LINCOLN CITY/LANCASTER COUNTY PLANNING STAFF REPORT

P.A.S.: Special Permit #1939A
Nebraska Heart Hospital

PROPOSAL: To revise the site layout and adjust the boundary for special permit #1939, which includes an 80 bed hospital and a 30,000 square foot medical office building.

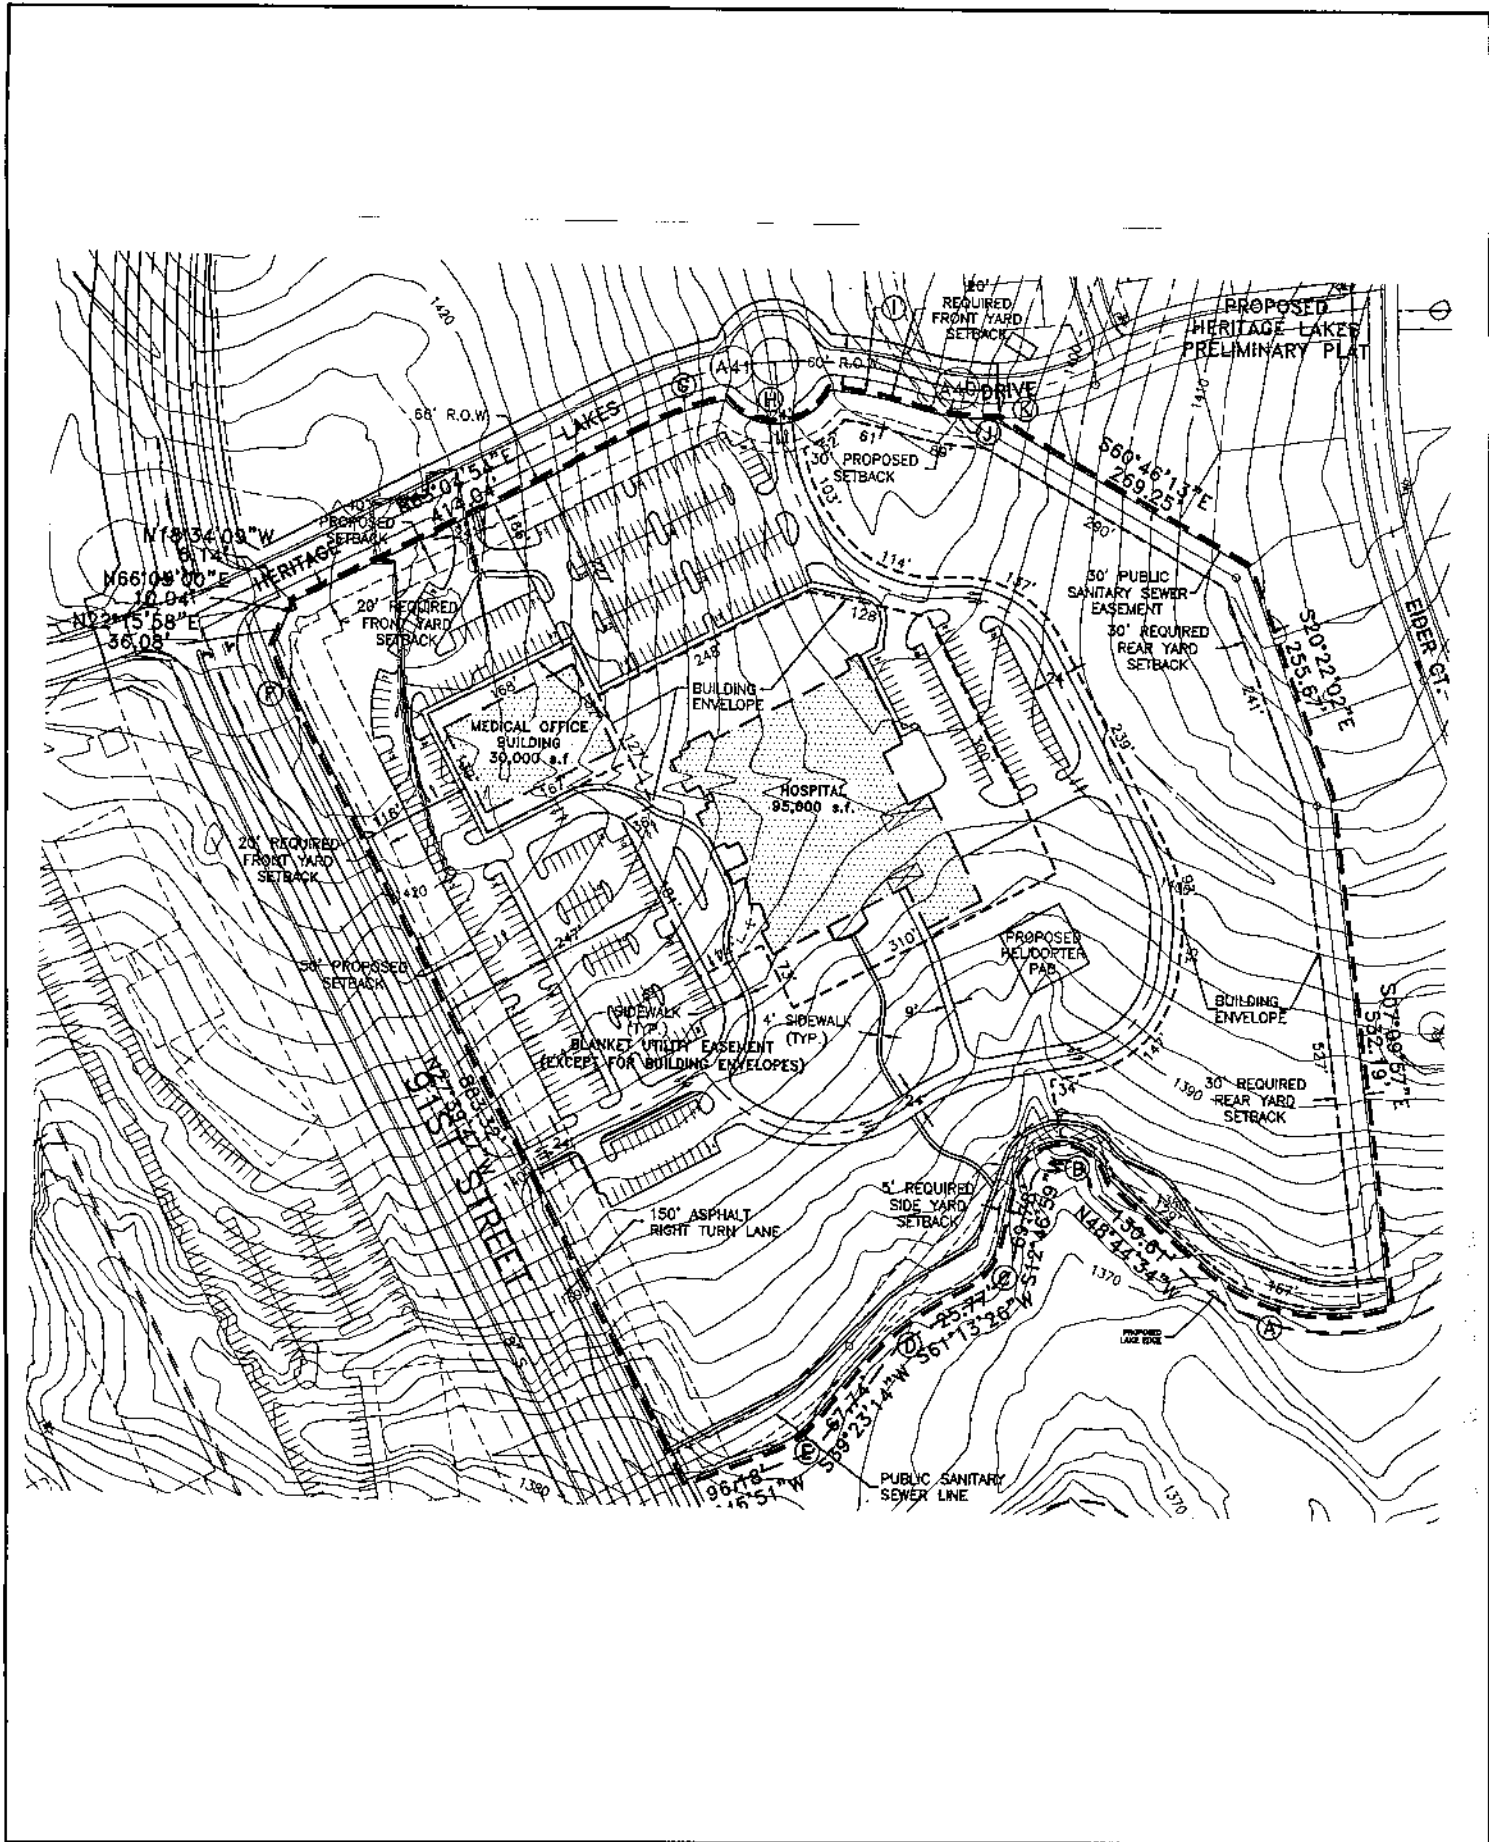
- 1.2.7 Provide building elevations as required by §27.63.080(b)(3).
 - 1.2.8 Relocate the "40' Proposed Setback" label that is currently next to the word "Heritage." It would be easier to read if it were north of the street.

- 1.2.9 Change the "Building Envelope" label to read "Proposed Future Residential Building Envelope."
 - 1.2.10 Provide a 50' landscaped buffer along the east property line, as was approved with special permit #1939.

- 1.2.17 Move the “30' proposed setback” label (currently located near the traffic circle) so that it does not crowd other dimensions. There is a clear spot to the southeast.

- 1.2.18 Remove the “Outlot A (Blanket Utility Easement)” labels from the Landscape Plan.
 - 1.2.19 On the Landscape Plan, correct the proposed setback along Heritage Lakes Drive.

- 1.2.20 Label the bicycle trail along S. 91st Street.
 - 1.2.21 Revise Note 6 - “site” should be “sight.”
 - 1.2.22 Revise Note 5 to replace “use” with “special.”

- 1.2.23 Revise Note 24 to indicate NAVD 1988.
- 2. This approval permits a 95,000 square foot health care facility with 80 beds and a 30,000 square foot medical office building.
